Accessibility Design Review Report

Nepean Village Outdoor Precinct
Cnr of Station & Woodriff Street Penrith

Prepared for: Vicinity Centres

Phase: DA

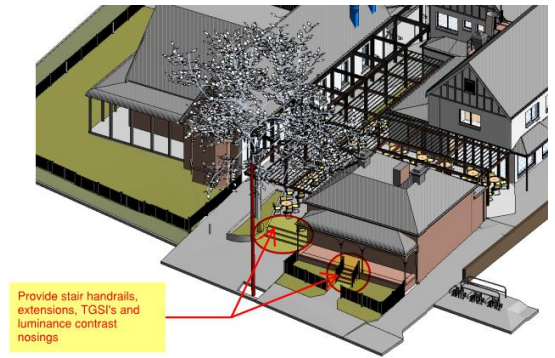
The external paths of travel to the site comprise of the following:

- Walkway access (gradient 1:24) via Station Street

- Stair access via Station Street.
 - Two stair access is noted to be provided:
 - Stair access to the seating courtyard
 - Stair access to historical structure is noted to be existing
 - As part of the accessible path of travel both stairways shall be provided with handrails to both sides and extensions with TGS's and stair nosings.

Level access is adequately provided via graded pedestrian walkways throughout the development providing connecting links from:

- The boundary to the main entrances at ground level
- Where there are changes in surface materials, ensure that a level surface is provided. Construction tolerance of 3mm is acceptable

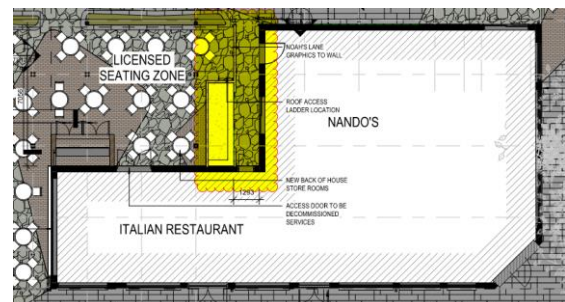
- Access corridor within this development consist only to exempt areas to the store room
- This access corridor is intended to be a BOH area not required to be accessible and will not be required to comply with AS1428.1-2009 – refer to areas highlighted in yellow

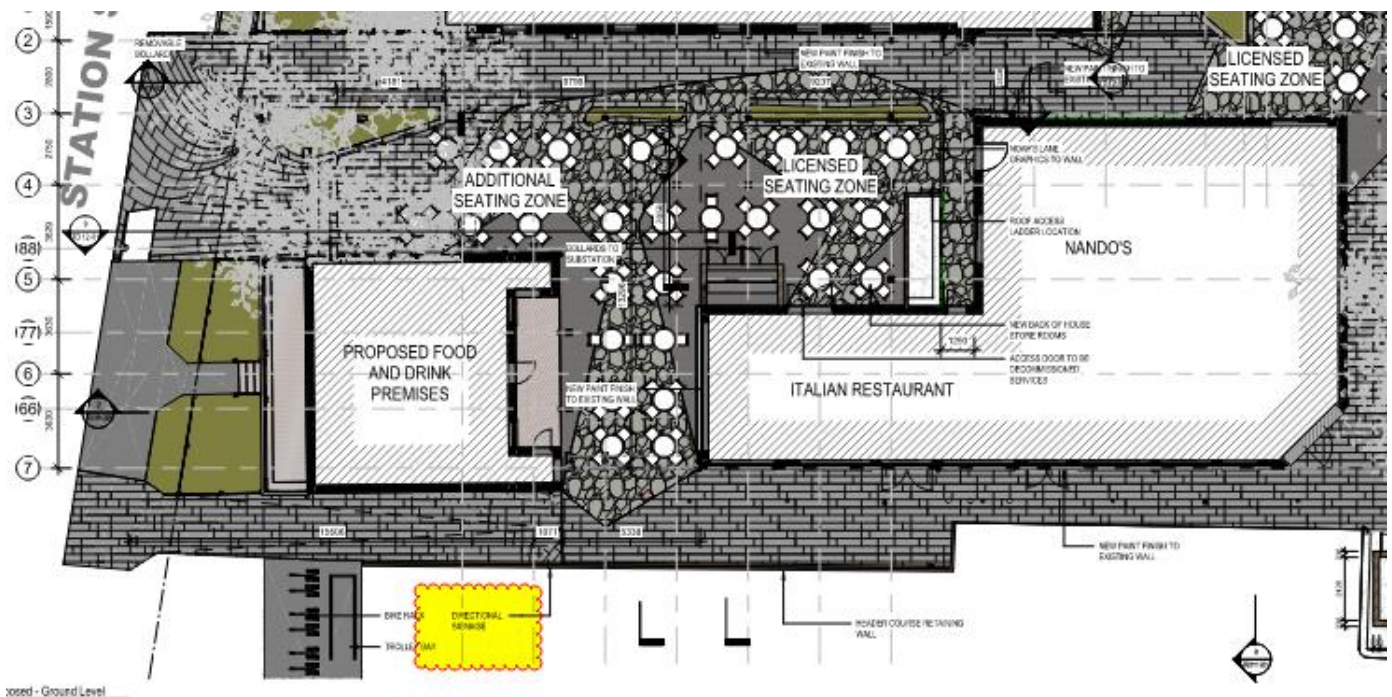
Where a pedestrian entrance is not accessible, directional signage incorporating the international symbol of access, in accordance with AS 1428.1 must be provided to direct a person to the location of the nearest accessible pedestrian entrance. This type of signage is required at the stair access points directing the visitor to the location of the ramp/walkway entrance.

- It is noted that directional signage is located adjacent to the 1:24.2 walkway
